Product Equality Declaration

We, **HMD Global Oy**, as the manufacturer, hereby declare that we are only and fully responsible for our product **Tablet PC**, brand name: **NOKIA**, model name: **TA-1462**, FCC ID :2AJOTTA-1462 ,originally granted on 06/30/2022.

Original					After change

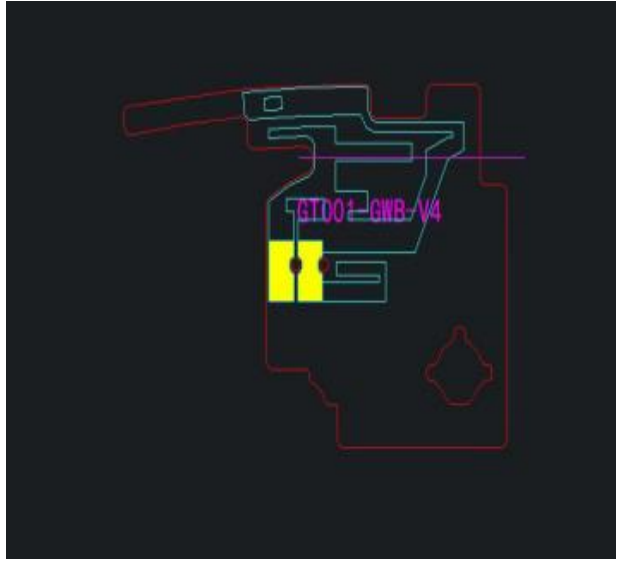
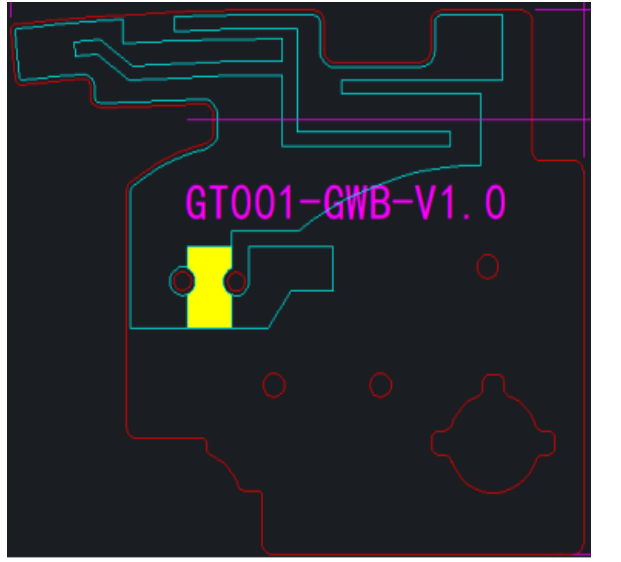
Now the antenna of three in one (Wi-Fi/BT/GPS) was changed. the PIFA antenna was changed to a monopole antenna. The other antenna, Main antenna, diversity antenna and FM antenna are unchanged, We have the same antenna version number, Only the printing was changed.

Frequency	Gain (dBi)	Efficiency (dB)	Efficiency (%)	Antenna Type	Frequency	Gain (dBi)	Efficiency (dB)	Efficiency (%)	Antenna Type
GNSS	-1.5	-3.99	39.92%	PIFA	GNSS	-1.56	-3.81	41.63%	MONOPOLE
2.4G BT&WIFI	-0.5	-4.3	36.1%	PIFA	2.4G BT&WIFI	-0.55	-4.1	38.91%	MONOPOLE
5G WIFI	-0.5	-5.32	29.28%	PIFA	5G WIFI	-0.53	-4.92	32.18%	MONOPOLE
